Transmitted by the experts from France and
Germany

Informal document No. **GRSG-96-05**
(96th GRSG, 4-8 May 2009
agenda item 5)

Proposal for draft amendments to Regulation No. 118

The text reproduced below is a consolidated version of Regulation No. 118 including the modification introduced by ECE/TRANS/WP.29/GRSG/2009/6. The modifications to the existing text of Regulation No. 118 are marked in **bold** or strikethrough characters.

Figure 4
Apparatus for testing the capability to repel fuel or lubricant
(Dimensions in millimeters)]

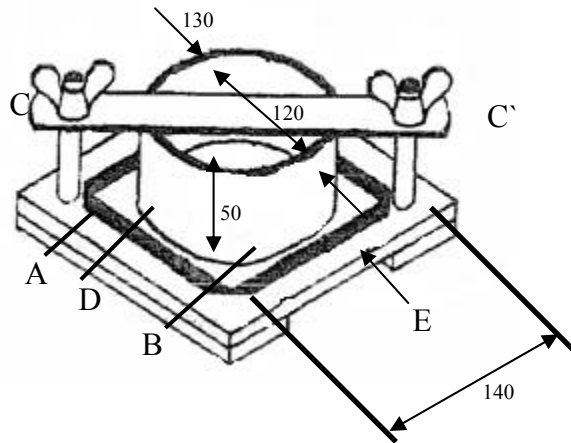
6.2.4. **All insulation material(s) and composite material(s) installed in the engine compartment and any separate heating compartment shall undergo the test described in Annex 9 to this Regulation.**

The result of the test shall be considered satisfactory if, taking the worst test results into account, the amount of absorbed test liquid is equal or less than [10]g/m².

Recesses necessary for technical reasons, e.g. tubes or structural members that need to pass through the material shall be allowed as long as the protection is maintained (e.g. sealant, tape ...).
